MONTICELLO NUCLEAR GENERATING PLANT
Docket No. 50-263 License No. DPR-22

REQUEST FOR AMENDMENT TO
OPERATING LICENSE NO. DPR-22

LICENSE AMENDMENT REQUEST DATED MARCH 11, 1976

PROPOSED CHANGES TO THE TECHNICAL SPECIFICATIONS, APPENDIX A OF
PROVISIONAL OPERATING LICENSE DPR-22

Figure 1. Propose Nitrogen Recirculation System.

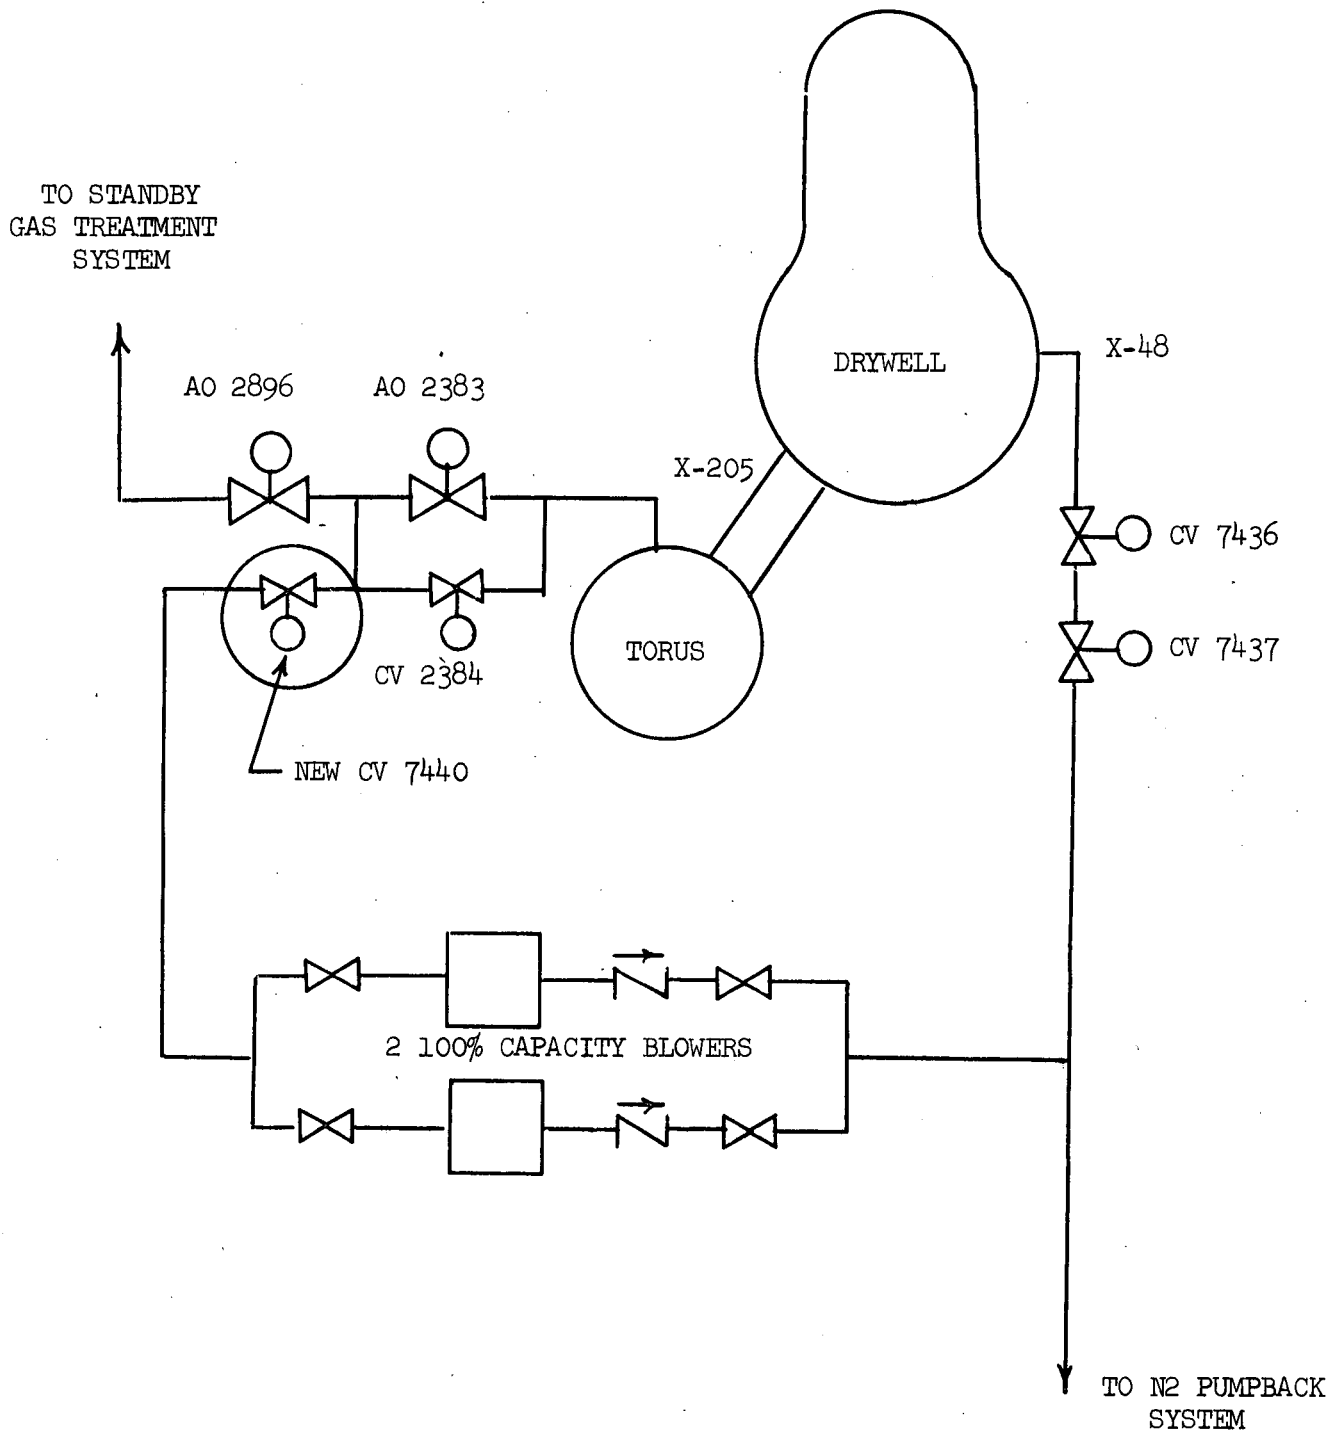
The proposed system (Figure 1) will remove nitrogen from the torus via CV-2384 and newly installed isolation valve CV-7440 using one of two blowers. The blower will discharge nitrogen to the drywell through two 1-inch isolation valves, CV-7437 and CV-7436, originally installed as part of a nitrogen pumpback system. Blower speed and recirculation flow will be manually adjusted to maintain the drywell pressure 1 psi above the torus pressure. The system, up to the second containment isolation valve in the suction and discharge lines, satisfies all design, quality assurance, and testability requirements set forth in 10 CFR 50.

A new 2-inch control valve, CV-7440, will be installed in series with CV-2384 to provide for double isolation of the supply line coming from the torus vent header. This valve will be controlled by the same circuitry that controls the outboard N₂ Pumpback isolation valve, CV-7437.

Figure 2. Group 2 Isolation Logic for Outboard Isolation Valves.

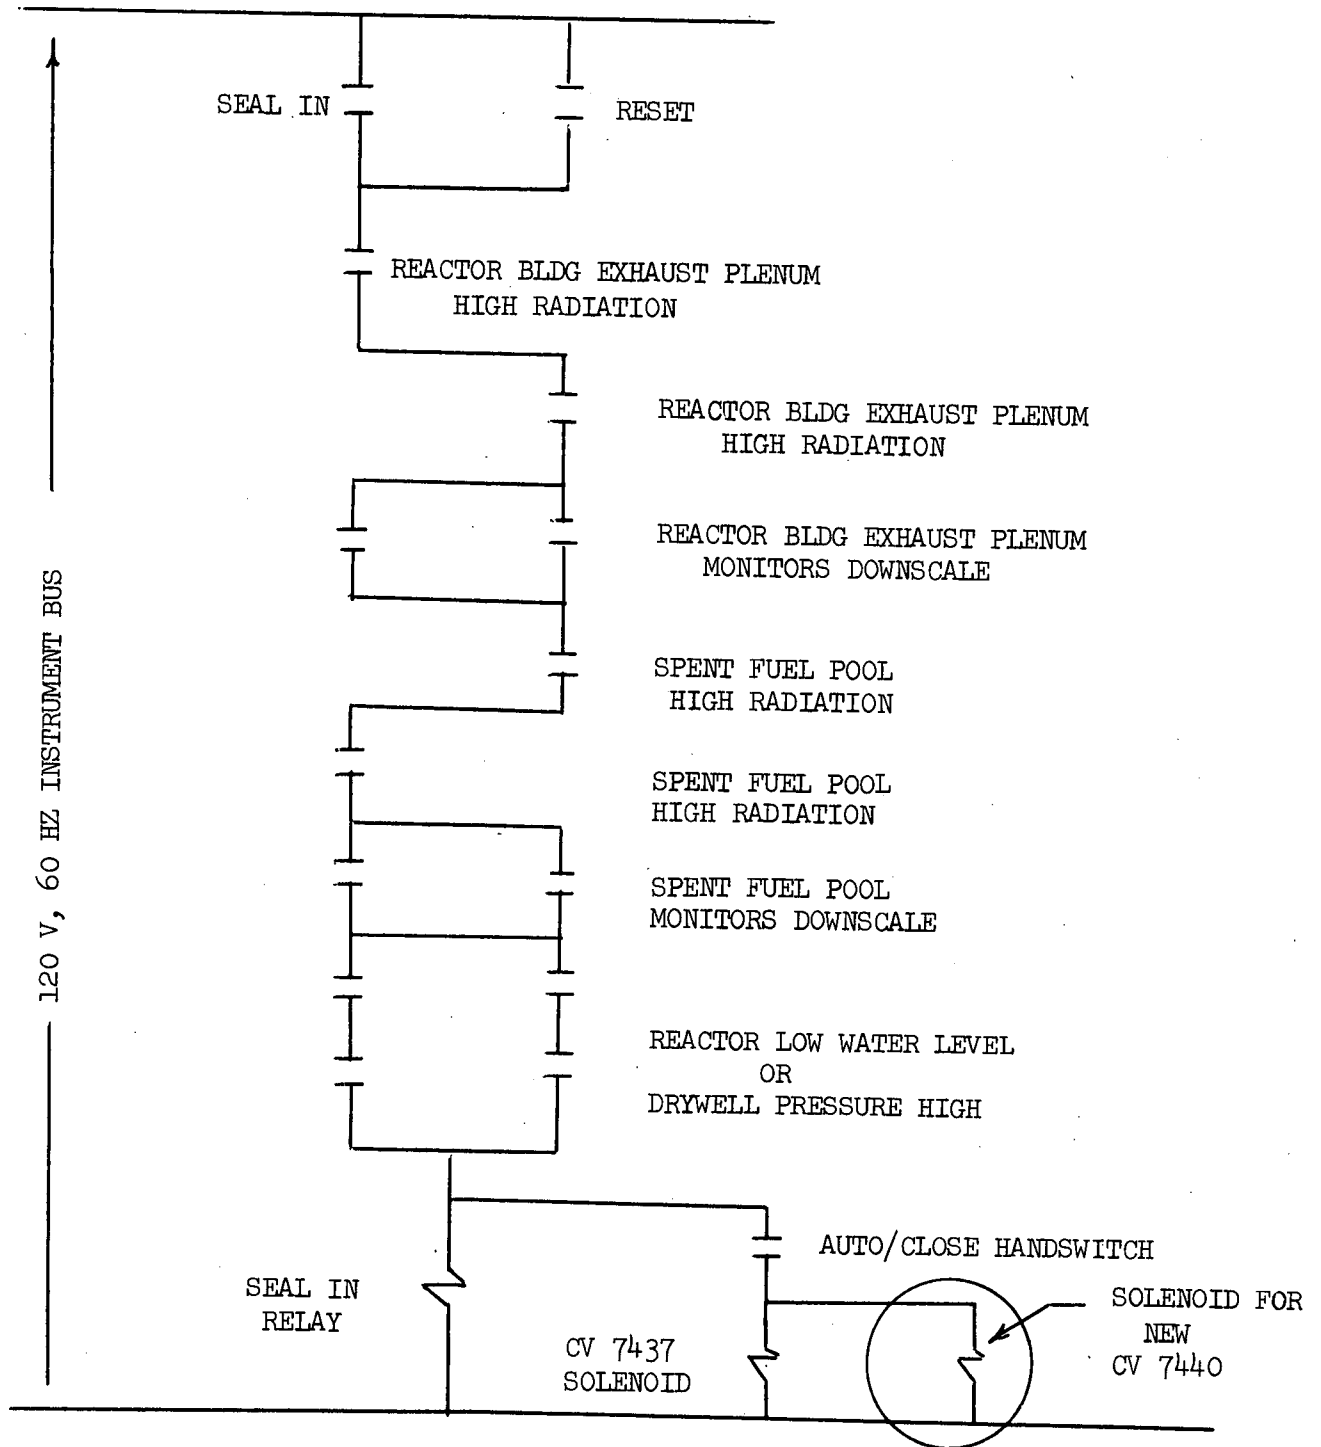
Since the isolation logic for the outboard isolation valves is separate from the inboard valves, the necessary separation criteria required for isolation valves in series is satisfied (Figure 2).

CV-7440 will be provided with limit switches which indicate if the valve is open or closed. These limit switches will be wired in conjunction with the limit switches of CV-7437 so that both valves must be closed to get the proper indication in the control room. The handswitch for CV-7437 will also control CV-7440.
